CITY PLANNING COMMISSION

APPLICATION: Planning Commission review of two office/warehouse buildings on 3.85+ vacant acres in the Heavy Commercial-Review (C-4-R) and General Commercial (C-2) Zones

C. NO. P84-260

BUILDING G AND H

SITE PLAN

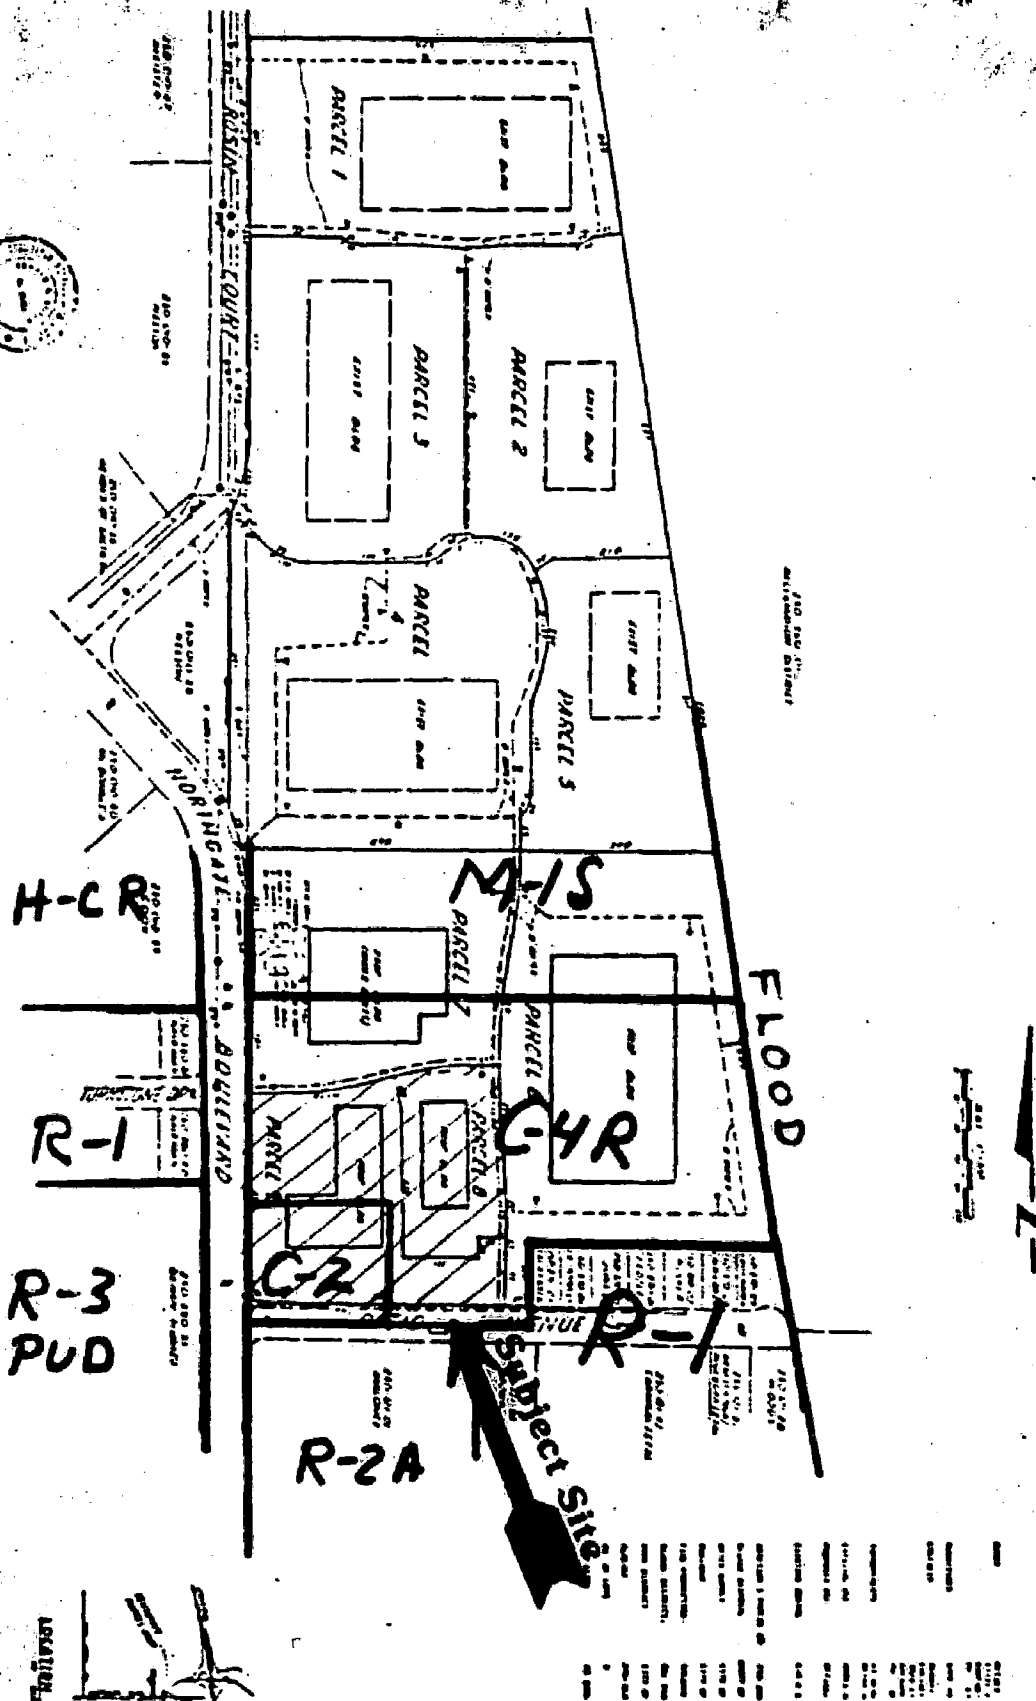
- a. No permits will be issued for driveways if property lines bisect driveways;
- b. A minor circulation problem at the east end should be corrected. See staff recommendation-Exhibit A. (This will reduce the number of spaces by two.)

6. Six parking stalls facing the west wing of Building H scale out to the 16 foot compact size. If they are to be standard 18 foot stalls, the applicant should be aware that the allowed two-foot overhand can only be over a landscaped area.

7. It should be noted that a portion of Building H is located in the General Commercial (C-2) zone which does not allow warehouse uses. The applicant/developer should rezone this C-2 portion to bring it into conformance with the rest of the parcel and its proposed use.

4. Parking lot circulation shall be redesigned as in Exhibit A;
 5. The trash enclosure shall be enclosed with a minimum six-foot masonry wall matching the main building material, with heavy gauge metal gates. It should be designed to allow walk-in access without having to open the gates;

7. Six parking stalls facing the west wing of Building H shall be labeled "compact", or the area redesigned for vehicles overhanging a landscaped area;

8. The General Commercial (C-2) portion of this site shall be rezoned to bring it into conformance with the rest of this project and its proposed uses. This must be approved by the City Council prior to any occupancy of Building H.
